**NEW YORK STATE THRUWAY AUTHORITY
DEPARTMENT OF ENGINEERING**

**ALBANY, NY
FEBRUARY 8, 2024**

**AMENDMENT NO. 1
TO**

**CONTRACT TANY 24-8
D214964
2" MILL AND INLAY, SAFETY
IMPROVEMENTS AND MISCELLANEOUS WORK
BETWEEN MILEPOST 47.6+/- AND MILEPOST 60.1+/-
IN THE NEW YORK DIVISION
OF THE NEW YORK STATE THRUWAY
IN ORANGE COUNTY**

Thruway Authority	TITLE OF PROJECT PAVEMENT RESURFACING AND SAFETY IMPROVEMENT	CONTRACT NUMBER: TANY 24-8
	LOCATION OF PROJECT NY DIVISION MP 48.0 TO 60.1	DATE: 1/2024
TITLE OF DRAWING GENERAL PLAN	DRAWING NUMBER: GP-20

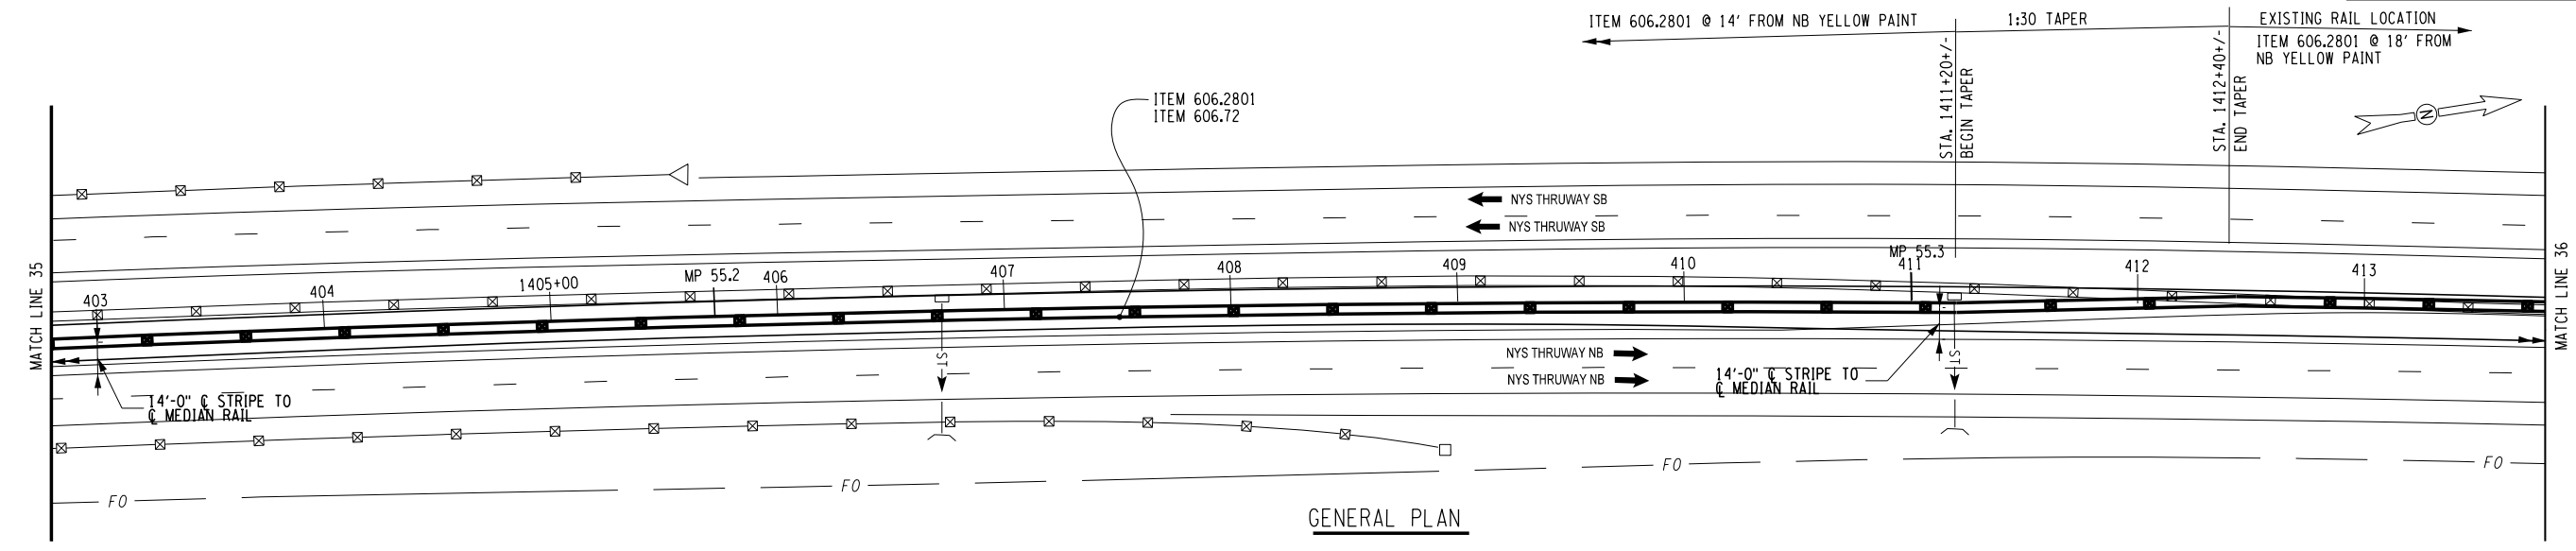
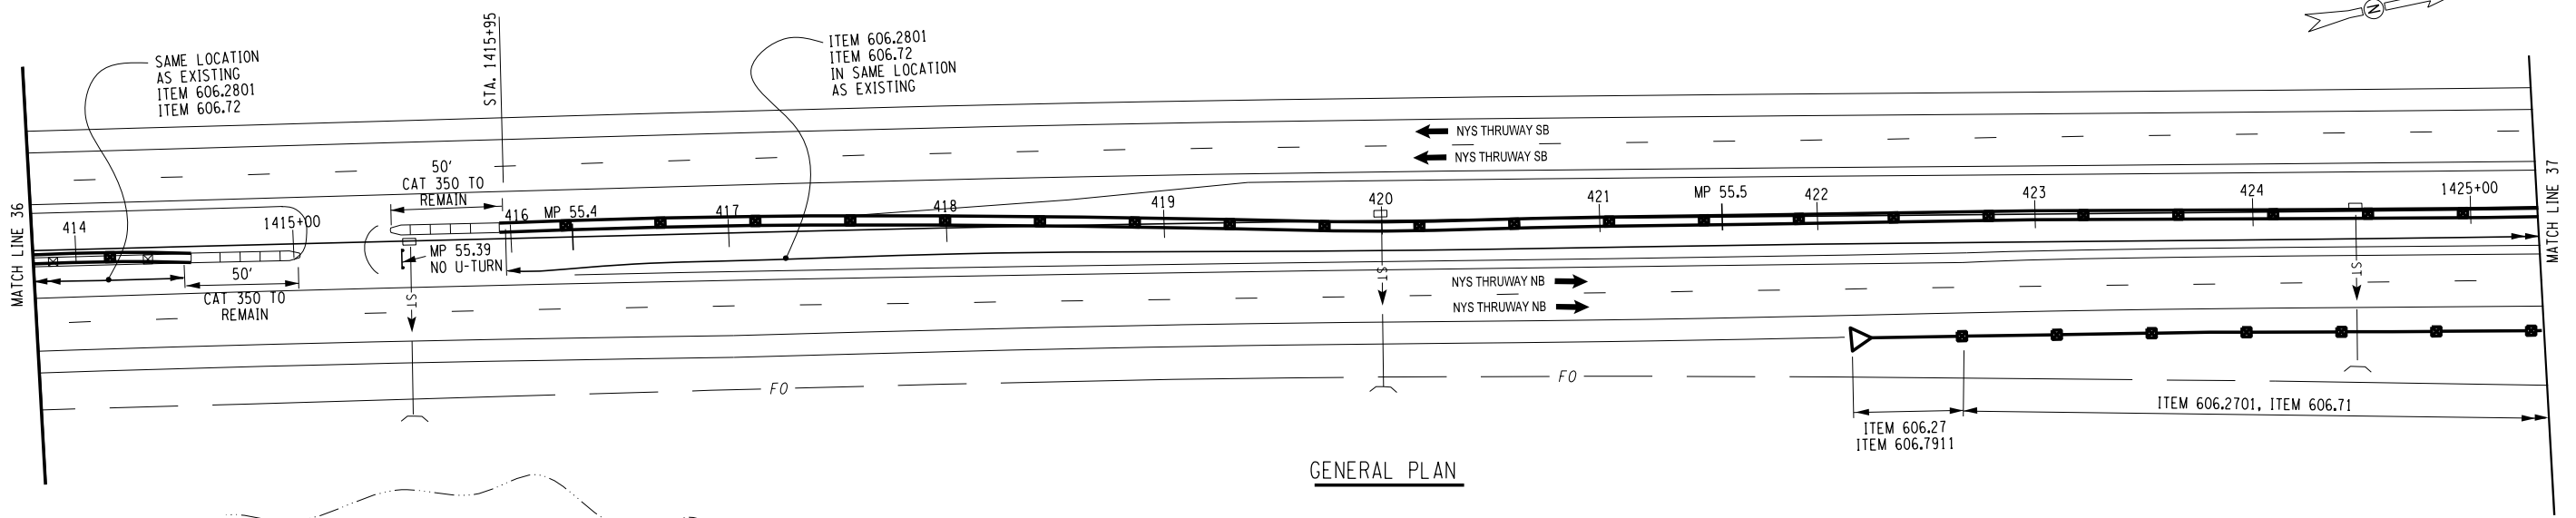
25. **DELETE** Drawing Number GP-20, Sheet 91 of 108, and **SUBSTITUTE** with the attached Drawing Number GP-20, Sheet 91-A1 of 108. Added location of proposed median rail to be “in same location as existing”. Changed proposed northbound right rail between sta. 1422+00 and matchline 37 from existing to proposed line weight. Delete Note 1.

NEW YORK STATE OF OPPORTUNITY Thruway Authority	TITLE OF PROJECT PAVEMENT RESURFACING AND SAFETY IMPROVEMENT	CONTRACT NUMBER: TANY 24-8
	LOCATION OF PROJECT NY DIVISION MP 48.0 TO 60.1	DATE: 1/2024
TITLE OF DRAWING GENERAL PLAN	DRAWING NUMBER: GP-21

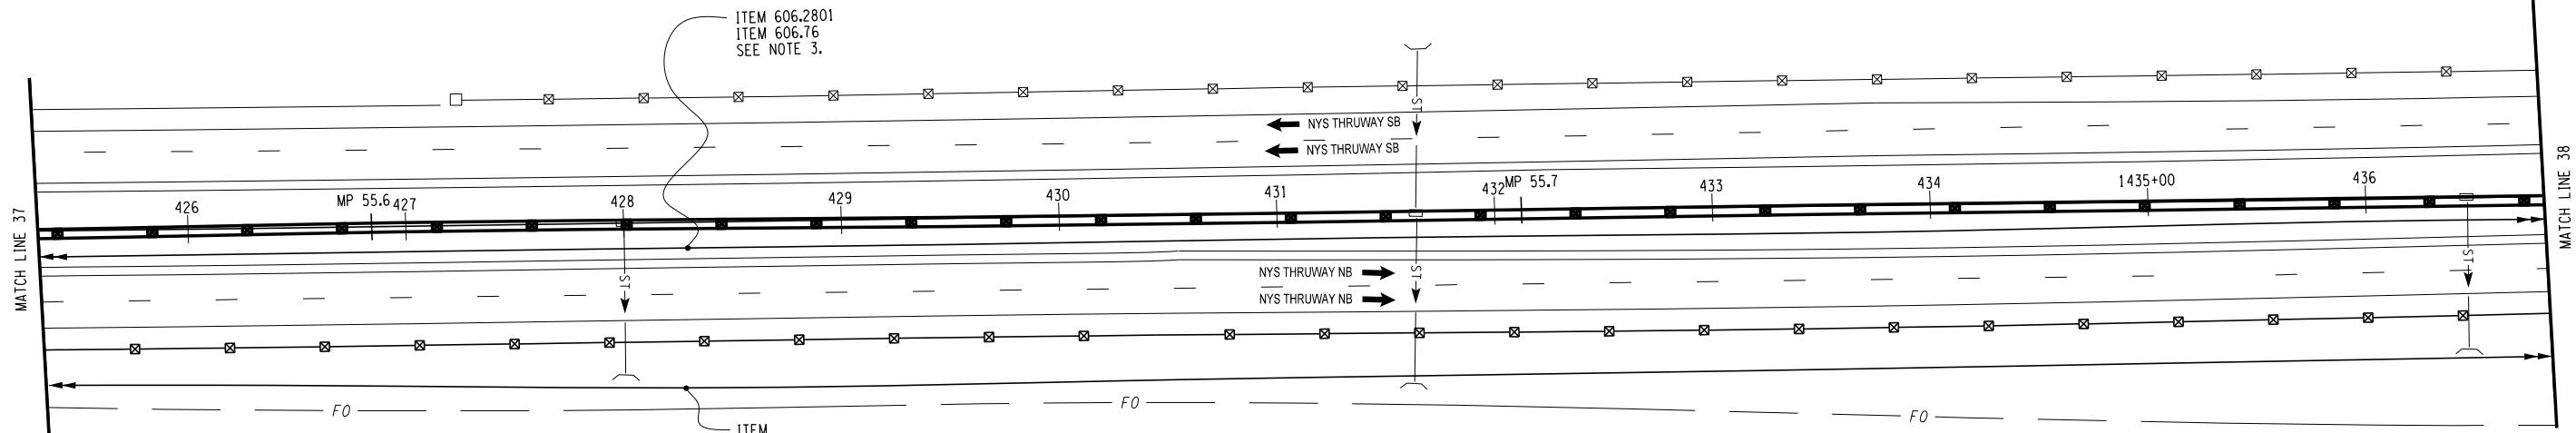
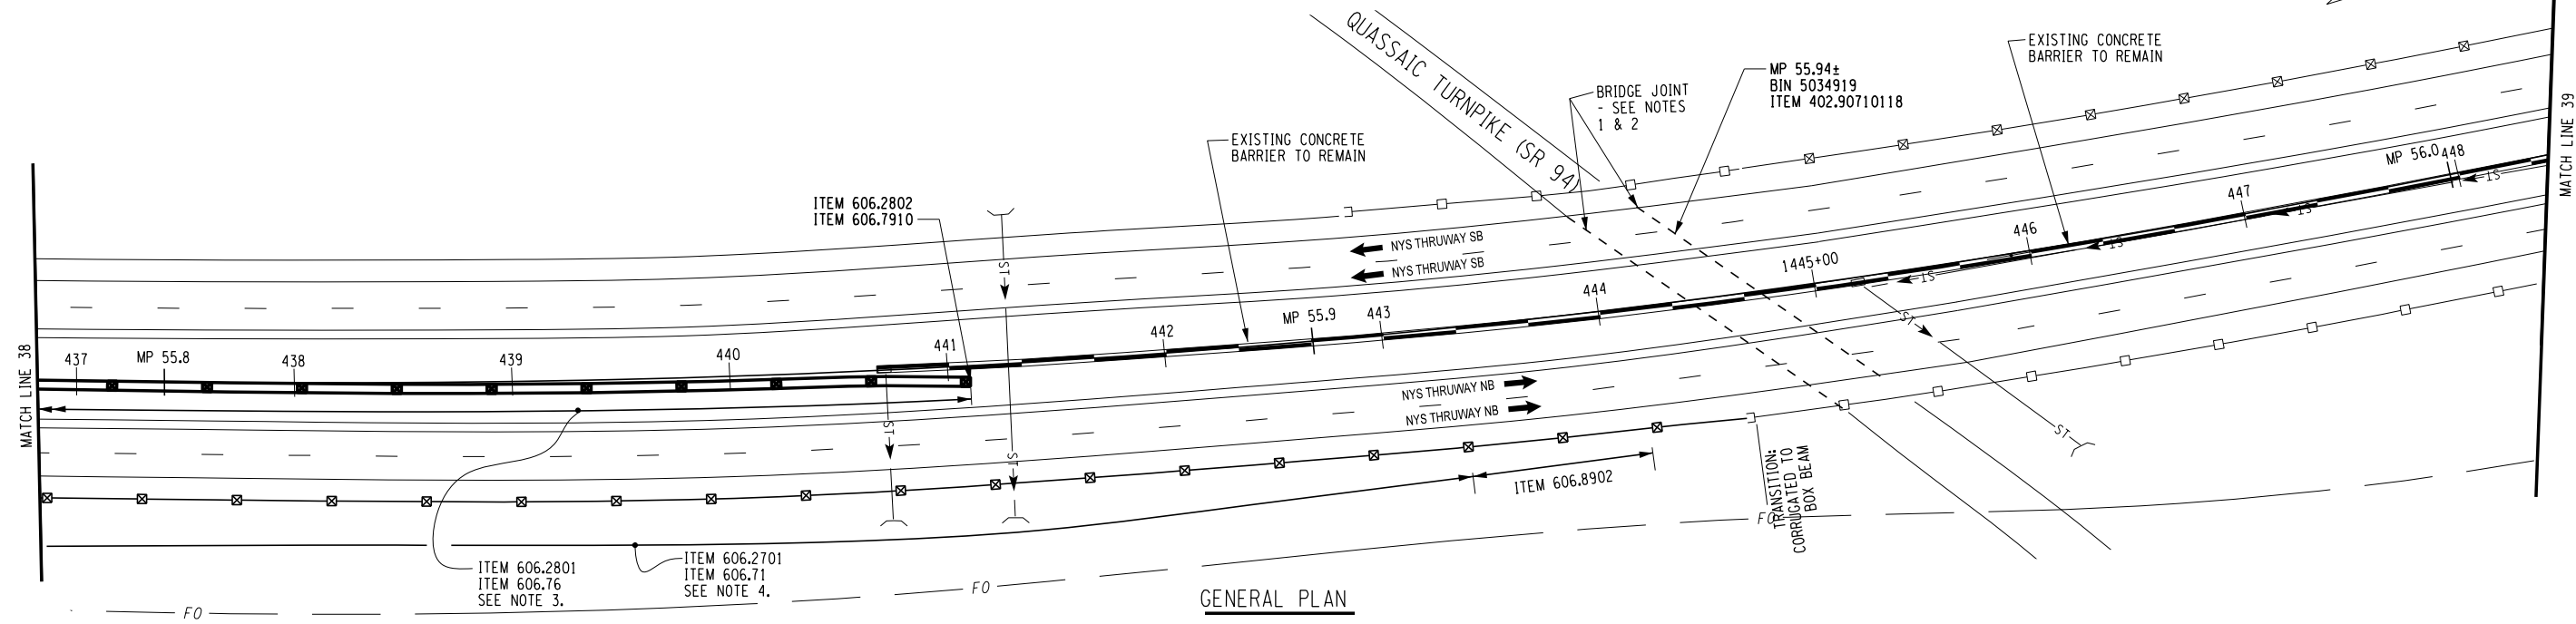
26. **DELETE** Drawing Number GP-21, Sheet 92 of 108, and **SUBSTITUTE** with the attached Drawing Number GP-21, Sheet 92-A1 of 108. Added two notes for “existing concrete barrier to remain”.

Thruway Authority	TITLE OF PROJECT PAVEMENT RESURFACING AND SAFETY IMPROVEMENT	CONTRACT NUMBER: TANY 24-8
	LOCATION OF PROJECT NY DIVISION MP 48.0 TO 60.1	DATE: 1/2024
TITLE OF DRAWING GENERAL PLAN		DRAWING NUMBER: GP-22

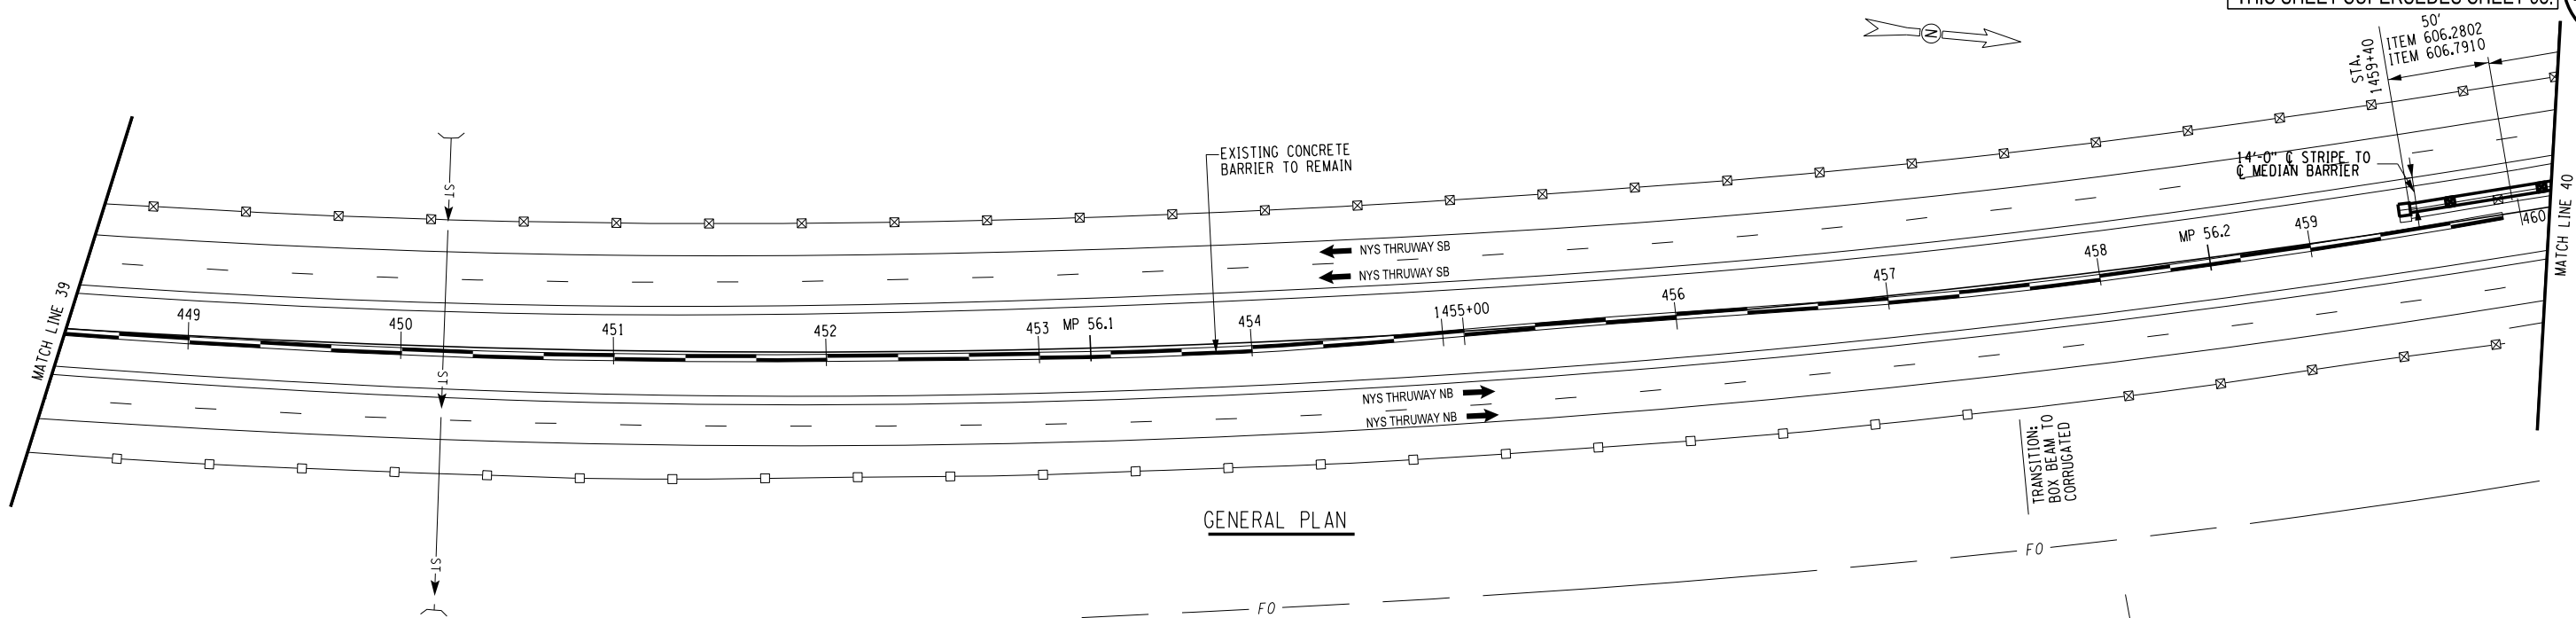
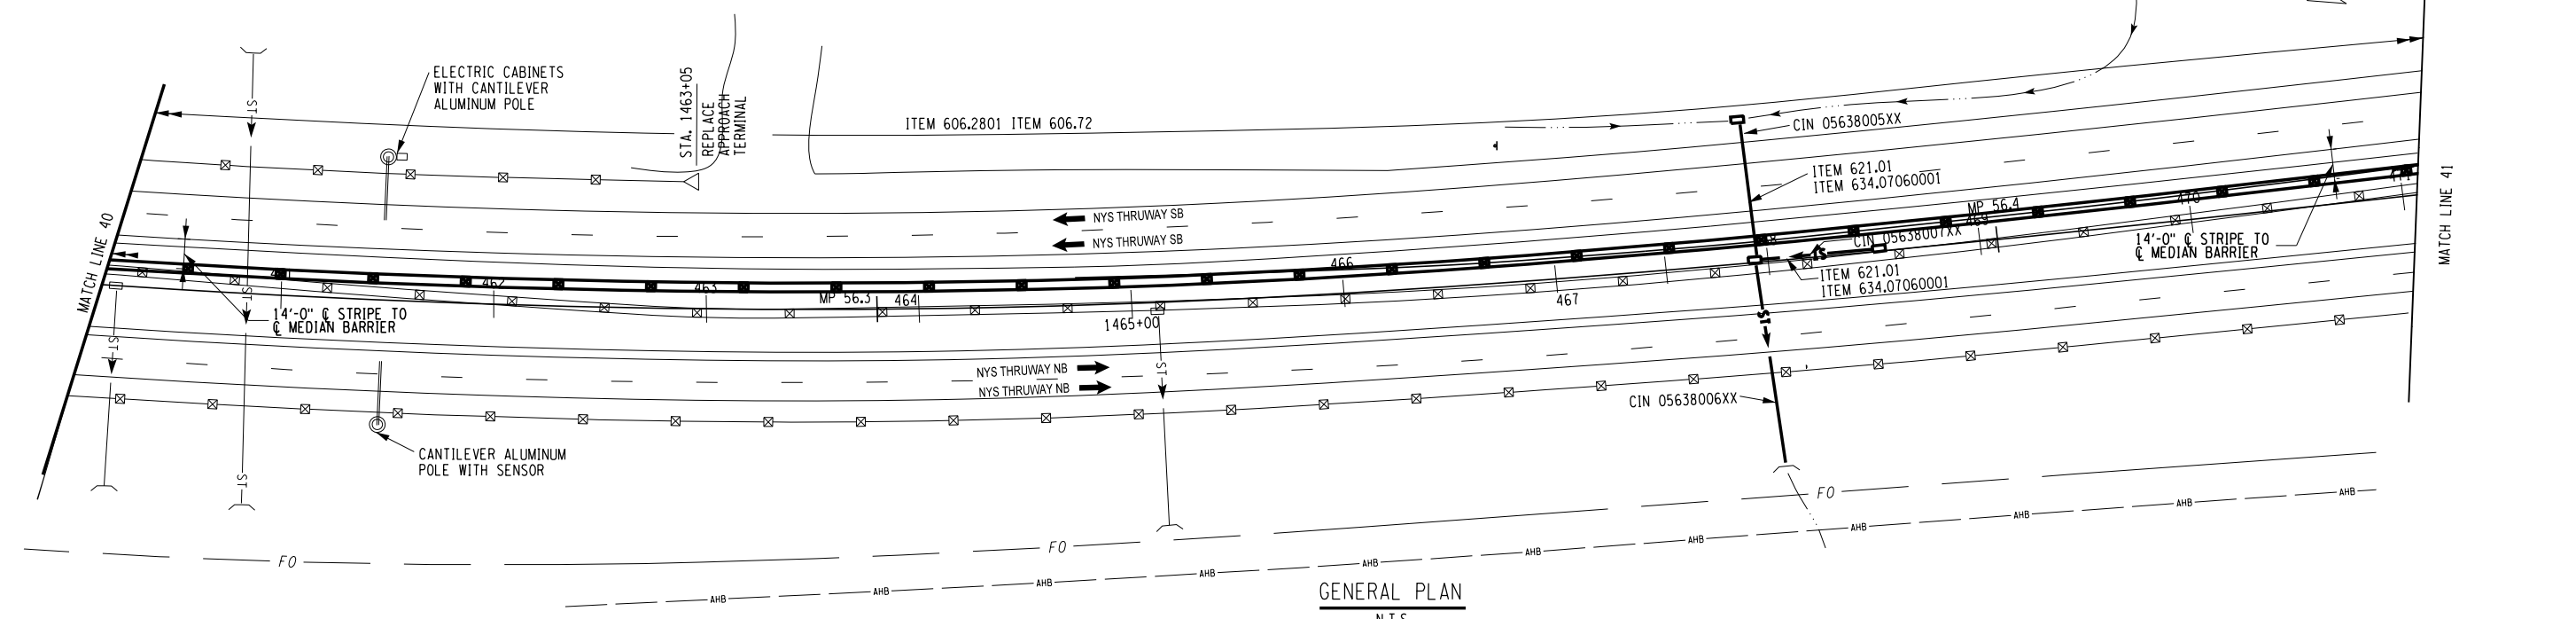
27. **DELETE** Drawing Number GP-22, Sheet 93 of 108, and **SUBSTITUTE** with the attached Drawing Number GP-22, Sheet 93-A1 of 108. Added a dimension line with locations of proposed items 606.2801 & 606.72 extents. Added one note for “existing concrete barrier to remain”.
